## REMARKS

Claims 1-46, 50-56, 59 and 60 are currently pending in the present application. The Specification has been amended solely to correct clerical errors or improve readability, and corrected Figures 1, 2, 6, 7A, 9, 12-16 and 18 are included with the Request for Drawing Change submitted with this response.

In the Office Action mailed October 11, 2001, claims 1-14, 18, 19, 23-31, 33, 35-38, 42-46, 50-56, 59 and 60 were rejected and claims 15-17, 20-22, 32, 34 and 39-41 were allowed. More specifically, the status of the application in light of this Office Action is as follows:

FIG. 16

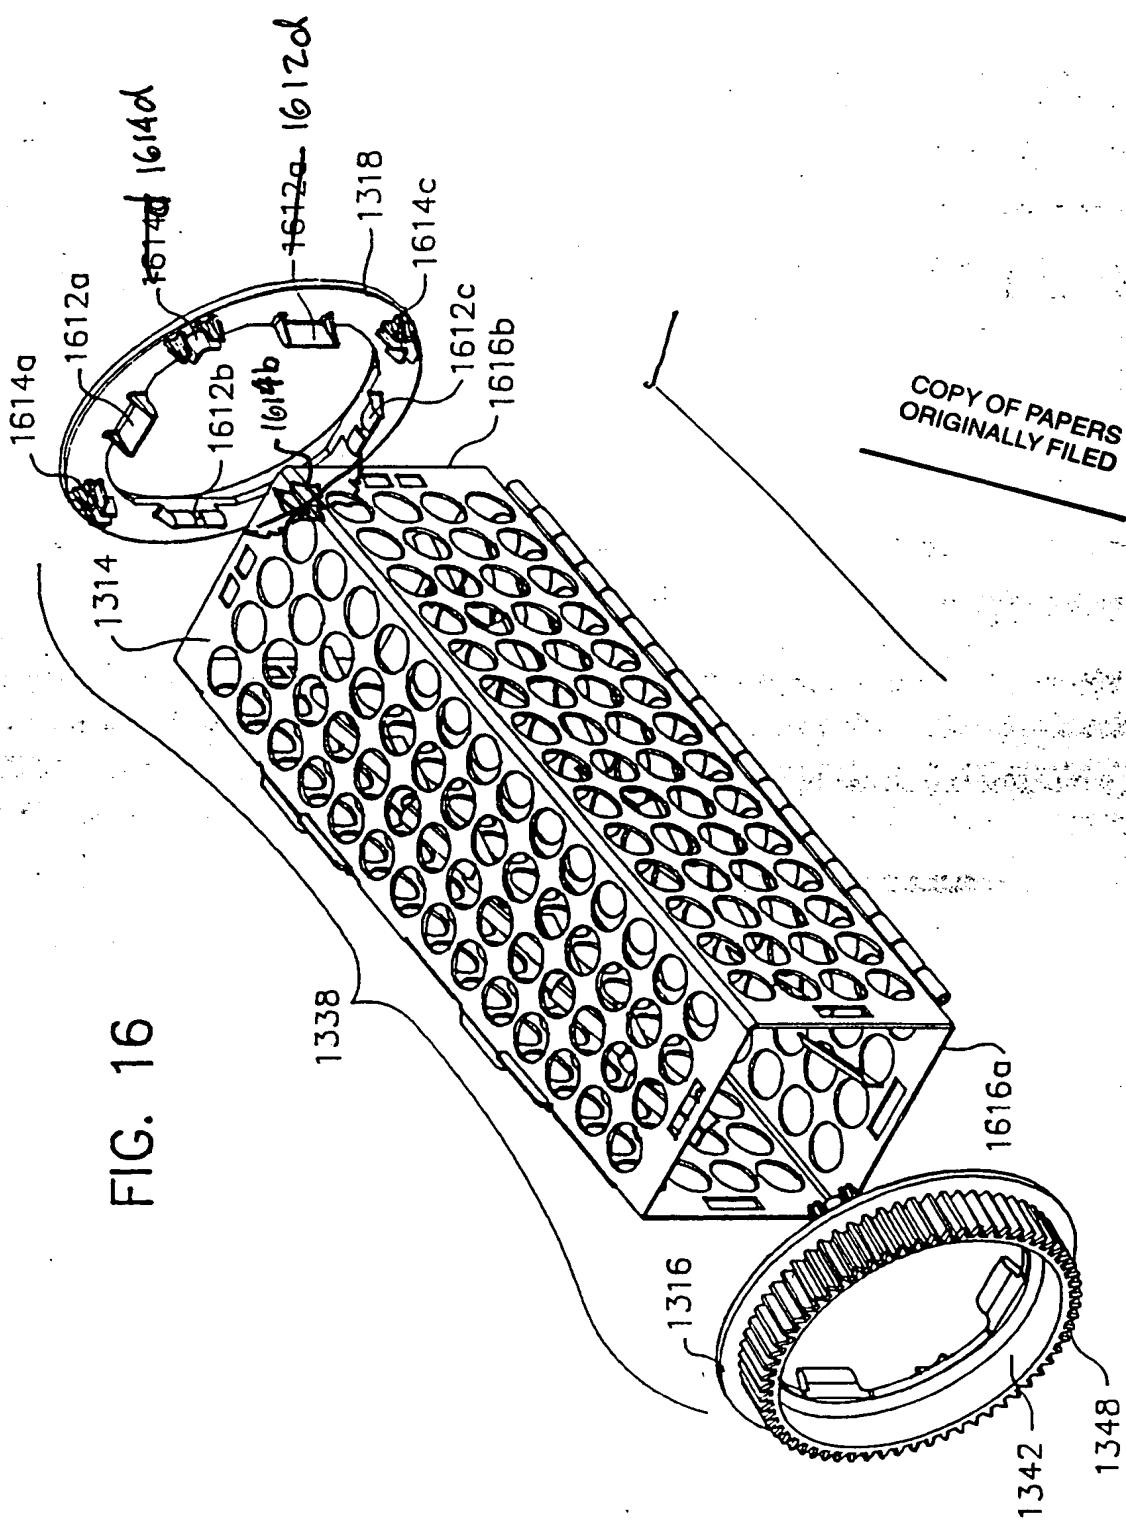
Figure 16 was objected to because items 1614[a] and 1612a were allegedly labeled twice, because items 1614d and 1612d were allegedly not labeled at all, and because items 1614b was allegedly not labeled and not shown. A corrected Figure 16 that replaces one of the reference numbers 1614[a] with reference number 1614d and one of the reference numbers 1612a with 1612d has been provided in the Request for Drawing Change submitted in response to this Office Action. In addition, the corrected Figure 16 shows element 1614b and labels it appropriately.

FIG. 18

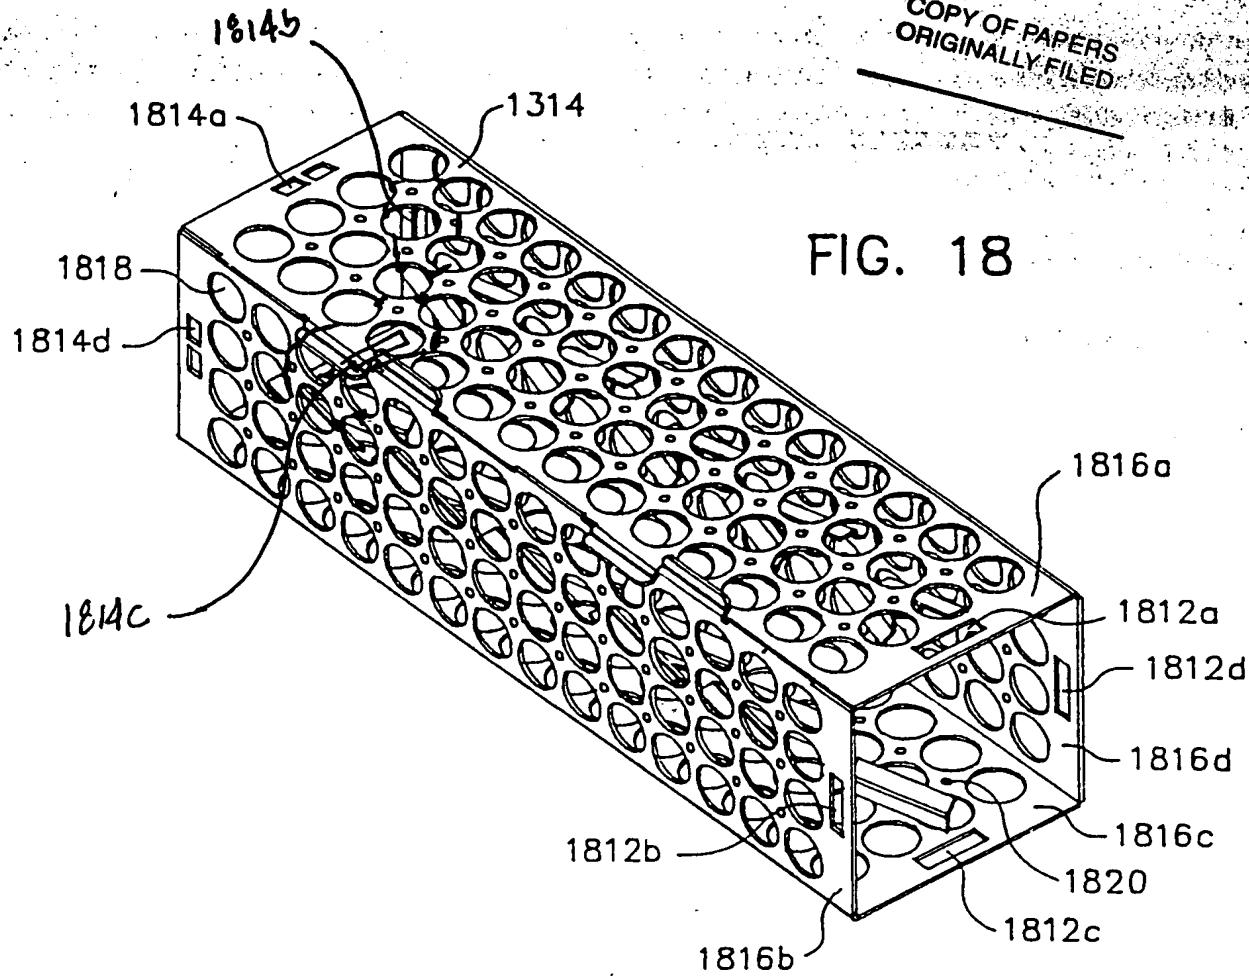
Figure 18 was objected to because elements 1814b and 1814c were allegedly not shown or labeled. A corrected Figure 18 with partial cutaways showing elements 1814b and 1814c correctly labeled has been provided in the Request for Drawing Change submitted in response to this Office Action.
